STEVE LARSEN
6891 MEWALL
6891 1/2 MEWALL
619-465-2240
PROJECT NO: 246265

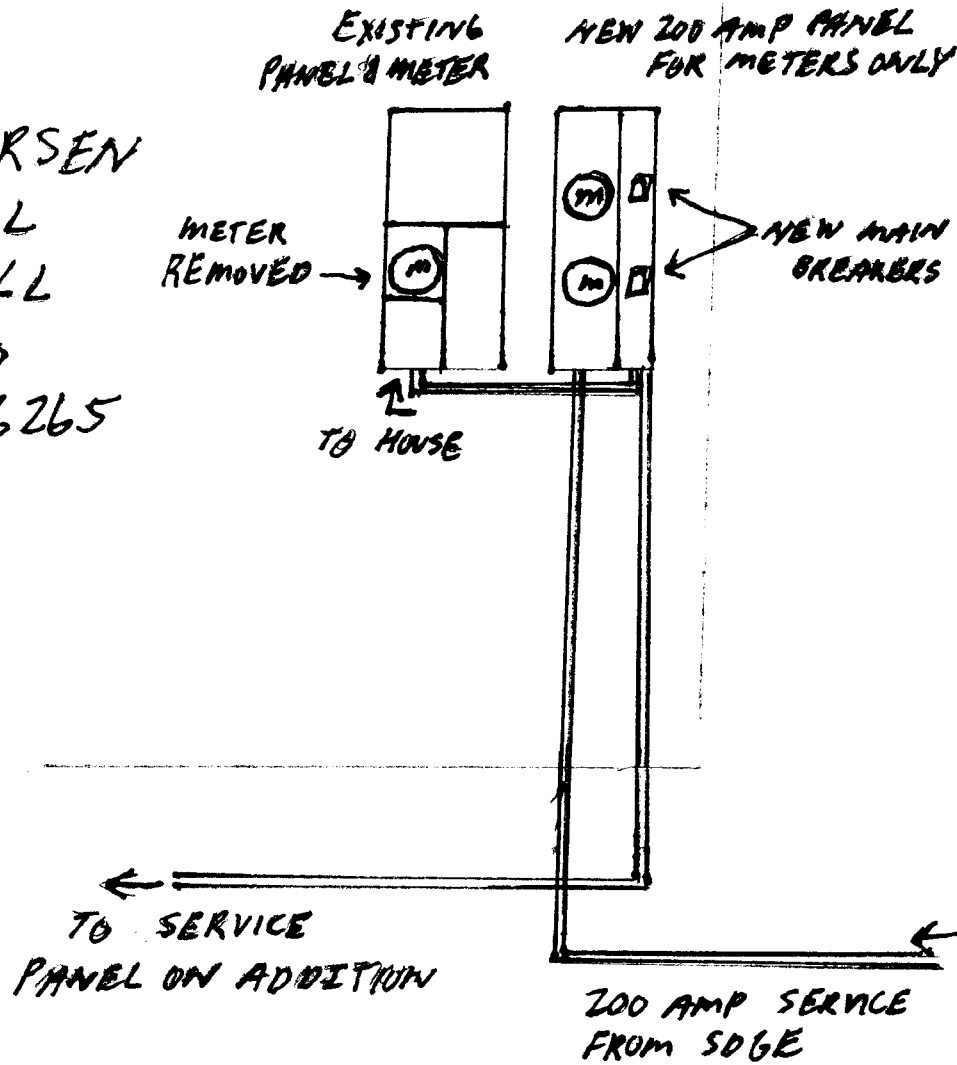
I SPOKE TO THE CITY ENGINEERS
AND THEY SUGGEST WE HANDLE THE
UPGRADE AS SHOWN ABOVE.

1. THE NEW PANEL WILL BE MOUNTED
SEMI-FLUSH.
2. THE LINE FROM SDGE WILL BE MOVED FROM
THE EXISTING PANEL TO THE NEW PANEL.

3. THE EXISTING METER WILL BE REMOVED AND THE EXISTING HOUSE PANEL CONNECTED TO THE NEW METER.
4. WHEN CONSTRUCTION IS COMPLETED THE LINE TO THE SERVICE PANEL ON THE ADDITION WILL BE CONNECTED TO THE METER ON THE NEW PANEL.
